Product Change Notification / LIAL-19GWRY786

CCB 4846 Final Notice: Qualification of ATP7 as an additional assembly site for selected ATSAMC20xx, ATSAMC21xx, ATSAMD20xx, ATSAMD21xx and ATSAML21xx device families available in 64L VQFN (9x9x1mm) package.

CCB 4846
Pre and Post Change Summary
PCN#: LIAL-19GWRY786

ASE

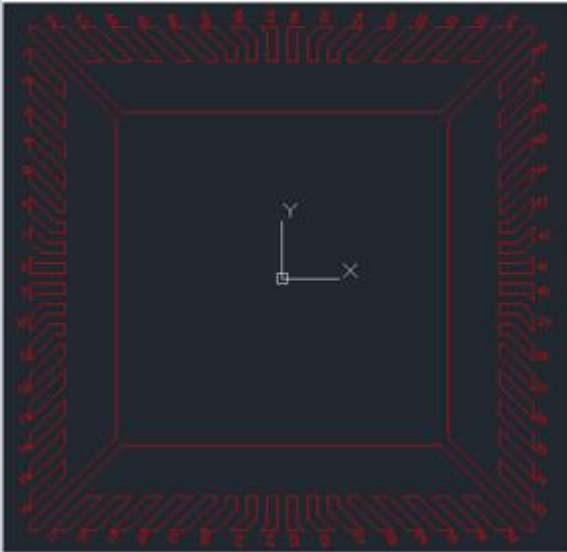
Lead frame comparison

Lead frame	Paddle size	193 x 193 mils
	DAP Surface Prep	Ring Plating

ATP7

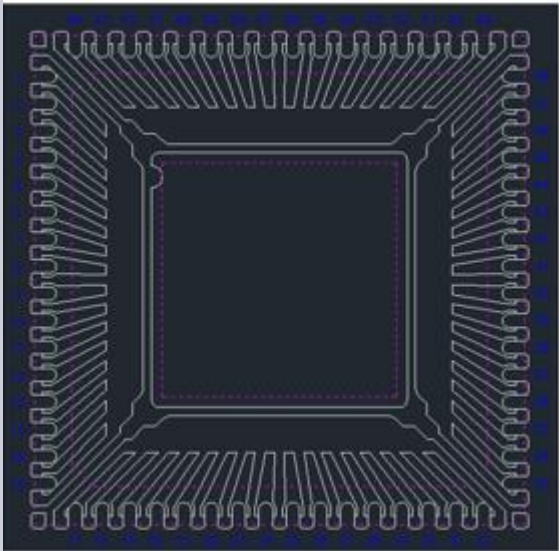
Lead frame	Paddle size	197 x 197 mils
	DAP Surface Prep	Double Ring Plating
